FOREST HILL WOODS SUBDIVISION, **RESUBDIVISION OF LOT 2**

Engineering Comments: FINAL PLAT COMMENTS (should be addressed prior to submitting the FINAL PLAT for review and/or signature by the City Engineer):

APPLICATION NUMBER 9 DATE February 16, 2017

DETAIL SITE PLAN

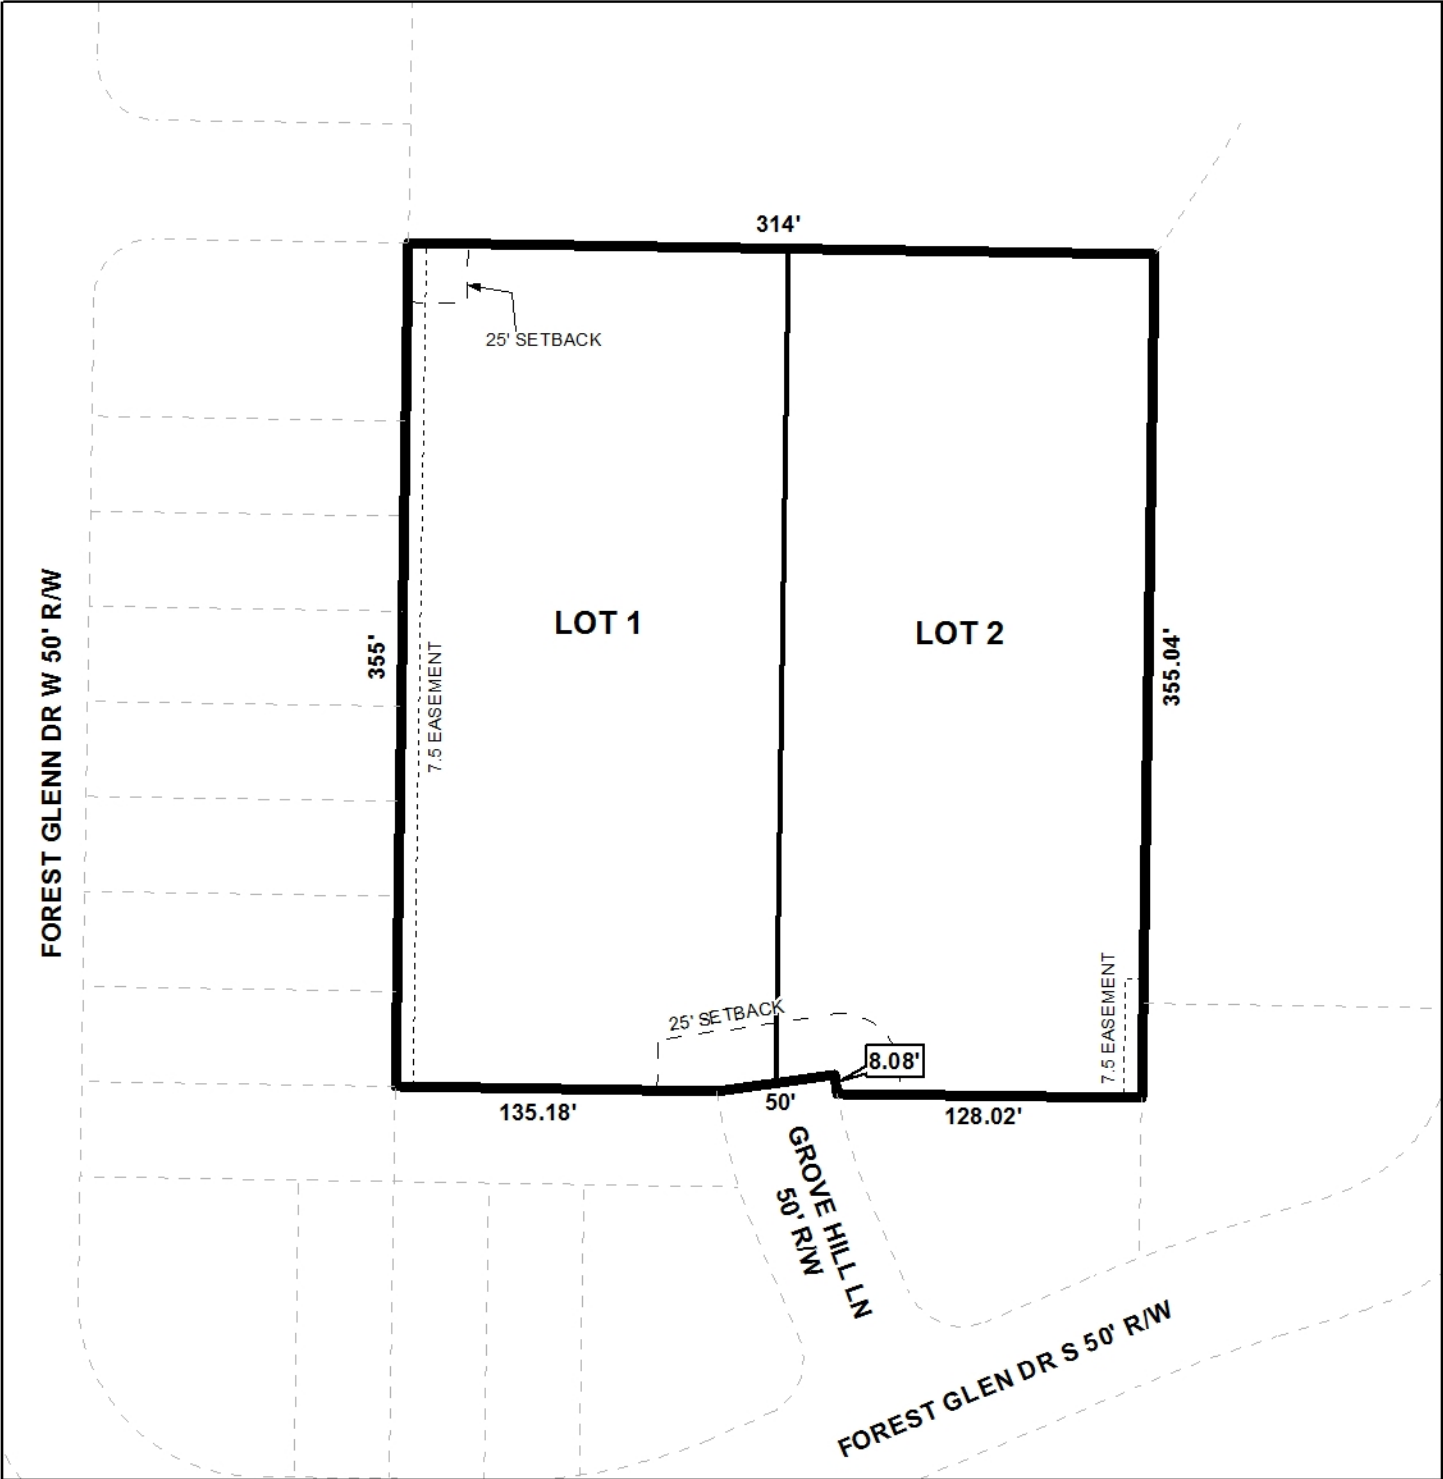
- C. Revise the 25 foot MBSL shown on LOT 2 along Grove Hill Lane to be parallel to the front property line.
- D. Provide and label the monument set or found at each subdivision corner.

The 25-foot minimum building setback line is depicted along the Southern perimeter of each proposed lot on the preliminary plat, and, if approved, should be retained on the Final Plat; however, the 25-foot minimum setback line shown on Lot 2 should be revised to be parallel with the front property line. Additionally, there is a 25-foot minimum setback area depicted at the Northwestern corner of the proposed Lot 1 near the terminus of Forest Glen Drive North. The 25-foot minimum building setback area should be removed from the Final Plat, if approved, as Forest Glen Drive North does not extend beyond this point. However, it should be noted, that if Forest Glen Drive North is extended in the future and the applicant further resubdivides the proposed Lots 1 and 2, a minimum setback building line of 25' is required along all provided street frontage. If approved, a note should be placed on the Final Plat stating such.

There is a 7.5' drainage easement depicted along the Western perimeter of the proposed Lot 1 and along the Southeastern perimeter of the proposed Lot 2. If approved, a note should be provided on the Final Plat stating that no structures are to be erected within any easement.
